## Attachment F

### List of Written Comments Rules 411 and 301

**RE: Amendments to AQMD Rule 411, NOx from Boilers, Process Heaters  
and Steam Generators**

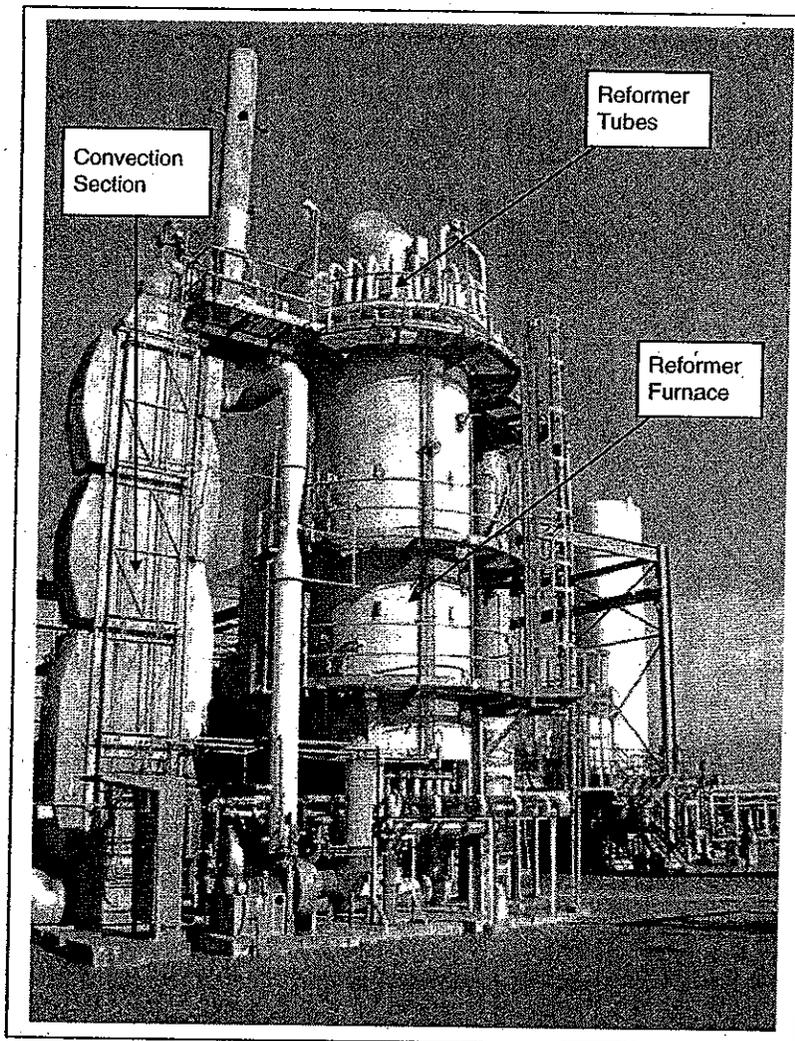
The two hydrogen plant reformer furnaces, A plant shown right (B is similar), fire purge gas with natural gas as the balance of the fuel. Purge gas accounts for more than 80% of the heat input to the furnaces on a calorific basis. A-plant came onstream 3/86 and B-plant, 6/89.

Each plant's furnace contains 3 up-fired burners surrounded by catalyst filled reformer tubes (A-26 tubes, B-32 tubes). In the convection section heat is recovered by generating process steam and preheating combustion air.

A-plant's furnace nameplate burner capacity is 19.1 MMBtu/hr but operates at about 25 MMBtu/hr, while B-plant's burners are nominally rated at 37 MMBtu/hr but operates at roughly 33 MMBtu/hr.

A and B NOx emissions average 22 ppm and 30 ppmvd respectively corrected to 3% O<sub>2</sub>; equivalent to 0.7 and 1.2 lb./hr of NOx, or about 8 tons/year total.
